## **RESOLUTION NO. 2022-034**

# A RESOLUTION OF THE CITY COUNCIL OF THE CITY OF ELK GROVE ADOPTING THE ADDENDUM TO THE SUPPLEMENTAL ENVIRONMENTAL IMPACT REPORT FOR THE MULTI-SPORT PARK COMPLEX AND GRANT LINE SOUTHEAST INDUSTRIAL AREA ANNEXATION PROJECT (WFC004)

Figure 2 – Water System and Phasing

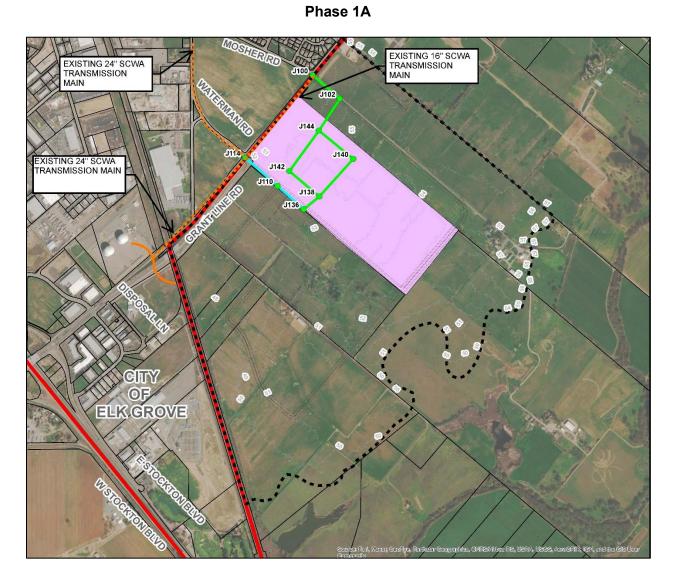
Based upon this information, the City has prepared a Technical Addendum to the Water Master Plan that outlines a strategy for delivery of the on-site water infrastructure in concert with the anticipated development sequencing. This sequencing involves the construction of a 12-inch pipeline from the intersection of Grant Line Road and Mosher Road south along the Grant Line Road frontage to the northern boundary of the City property, then across the City property to the extension of Waterman Road. This additional pipeline provides a second point of connection for development of the City, Kendrick, and Cypress Abbey properties such that minimum fire flows can be achieved. The proposed phasing is illustrated in **Figure 2**.

Figure 5 – Proposed Sewer Facilities

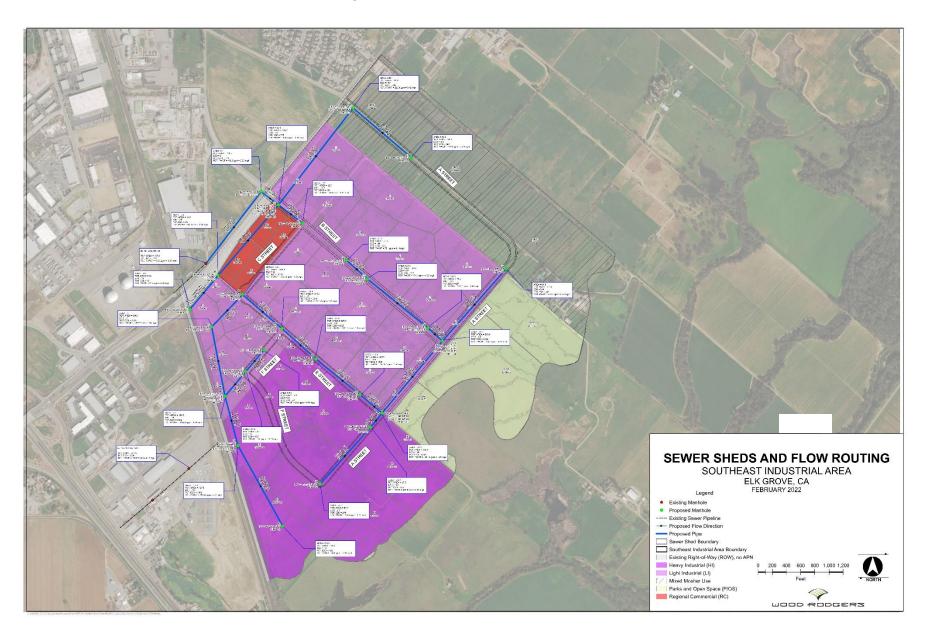
Because of the change in roadway alignments (as discussed herein) and the timing of development on the Cypress Abbey property, a new alignment for the on-site sewer connection to the Railroad Manhole is proposed. As shown in **Figure 5**, sewer facilities would be constructed along A Street and E Street north to approximately C Street, then extended southwest along the SMUD Transmission Line corridor to the railroad tracks, then southerly to the manhole. The proposed alignment meets the standards of SASD for facility design and will provided adequate sewer service for the Project's proposed land uses.
